**Re: Notice of Deficiency for the 2010 Annual Engineering Inspection Report
NABORS Class 4 Landfill**

Permit Number: 0249-S4

ANNUAL ENGINEERING INSPECTION REPORT
CLASS 4 LANDFILL
CURRENT CONDITIONS

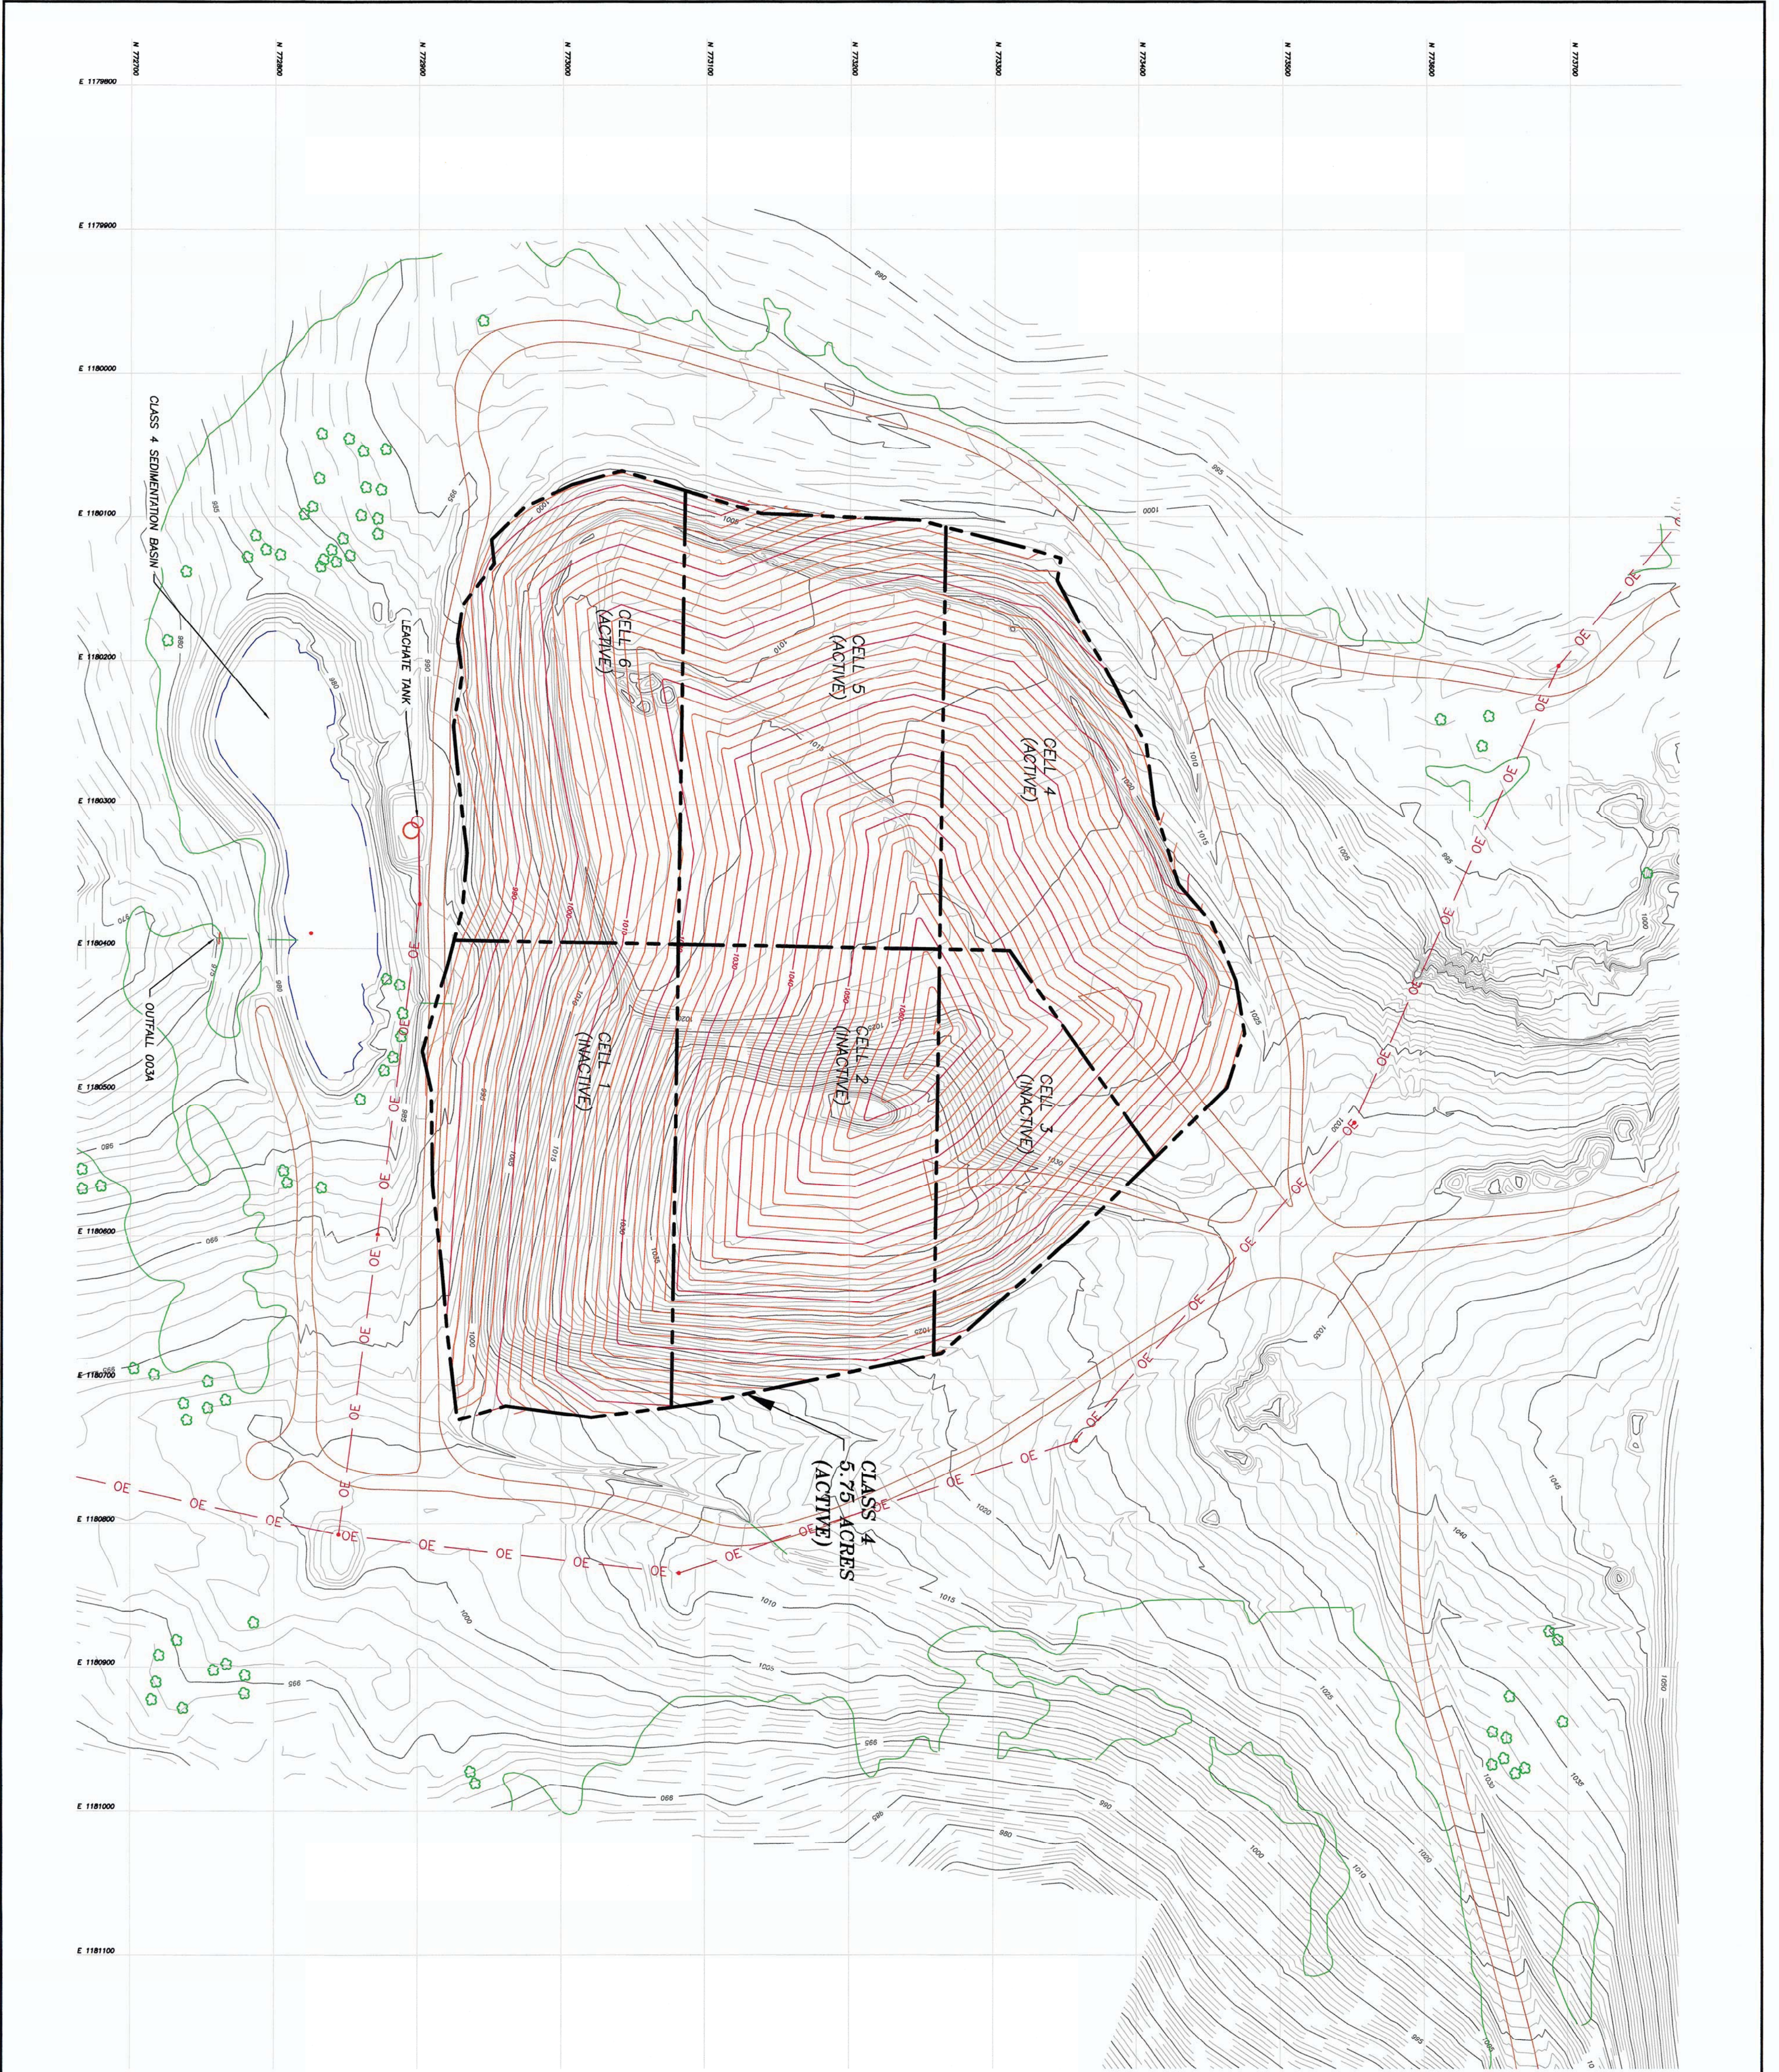
Comment 1: Drawing 3 - Current Site Conditions does not contain the grid coordinates.

Revised drawings including the grid coordinates are included in this response.

R6	---	6BY	---
R5	---	5BY	---
R4	---	4BY	---
R3	---	3BY	---
R2	---	2BY	---
R1	05/24/11	DWL	ADDED COORDINATES
REV.	DATE	BY	DESCRIPTION
